Transistorised Converter, CV-1

ENG-6-562

1. This memorandum summarizes the work recently completed on the transistorised converter project. The discussion includes the defects noted in the two units returned for repair, the modification which permits safer operation with AC-DC type receivers, and the characteristics of the two solar batteries recently forwarded for use with the unit. Instructions and photographs which cover the modification are attached. Precautions suggested for addition to field instructions are also included.

**MODIFICATION OF CV-1 CONVERTER FOR USE WITH AC-DC RECEIVERS**

TRANSISTORIZED  
RF CONVERTER (CV-1)  
16 DECEMBER 1955

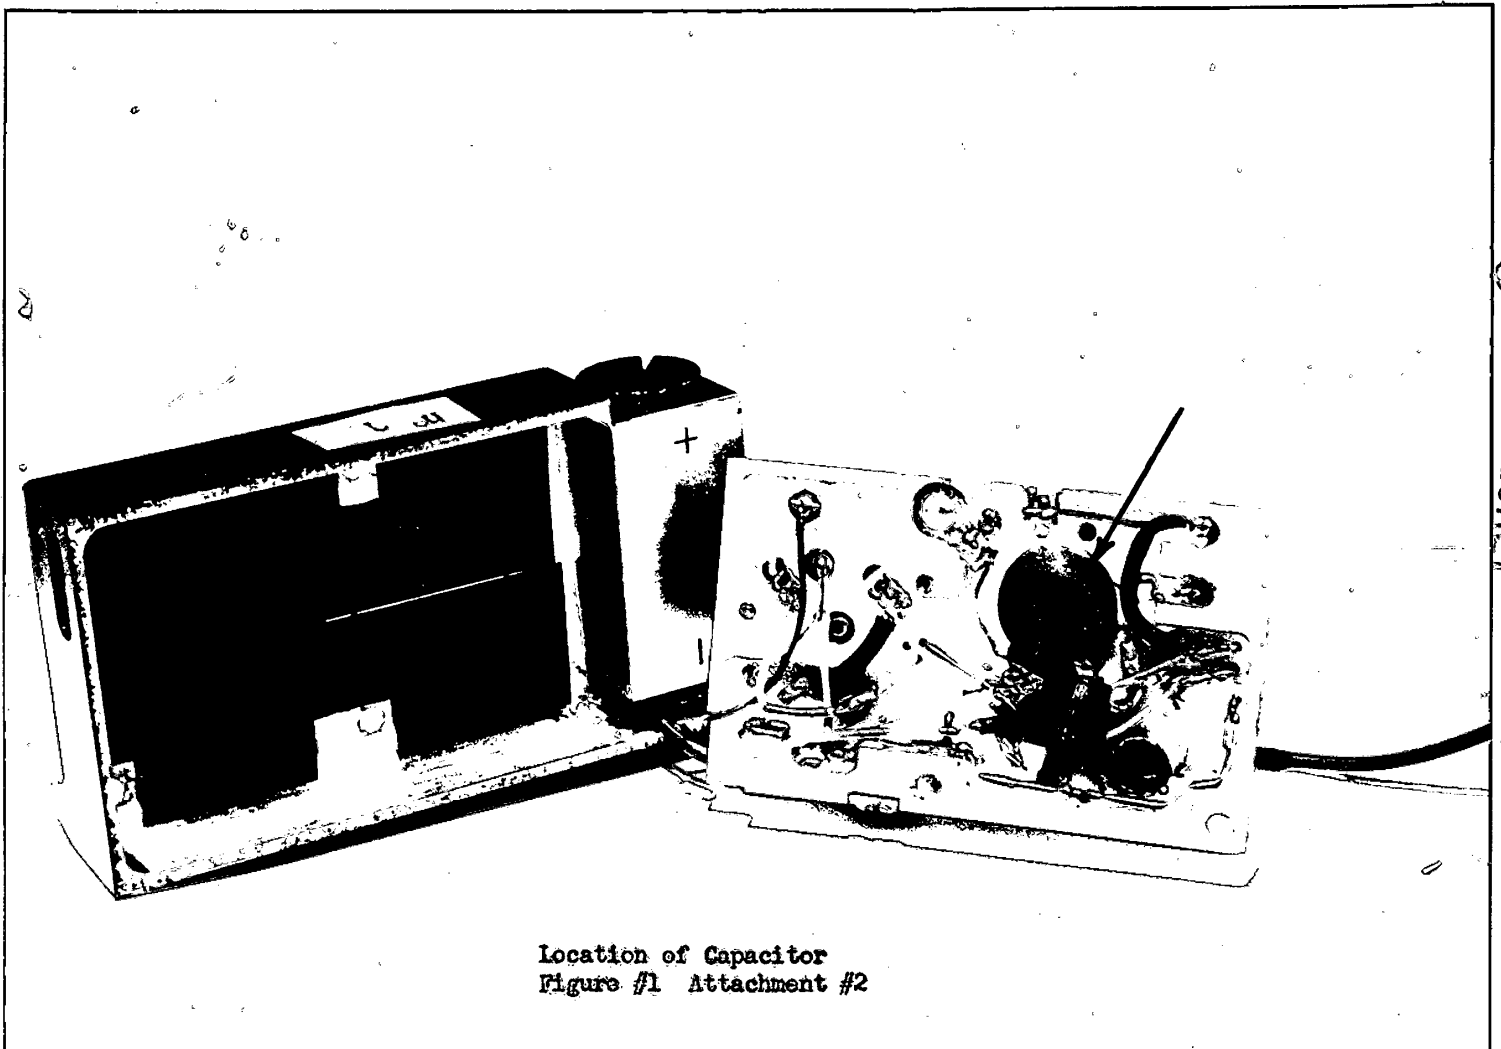
4. During the above modification an error was noted in the original converter schematic. In the oscillator circuit, the top end of the 47 K resistor and the bottom end of crystal socket 802 should show connected to the transistor base. This error has been corrected on the schematics which form a part of Attachment #2.

2. The modification consists of isolating the secondary of transformer  $T_2$  from the converter chassis by inserting a 0.005 uf capacitor in series with the transformer lead to chassis ground. The physical location of this capacitor is shown in Figure #1.

- (d) Place a 0.005 uf ceramic capacitor in the vacant area below the tuning capacitor. (See Figure #1 and the attached schematic)
- (e) Remove the 3/8" 4-40 screw and replace with a 1/4" screw if it interferes with the positioning of the capacitor.
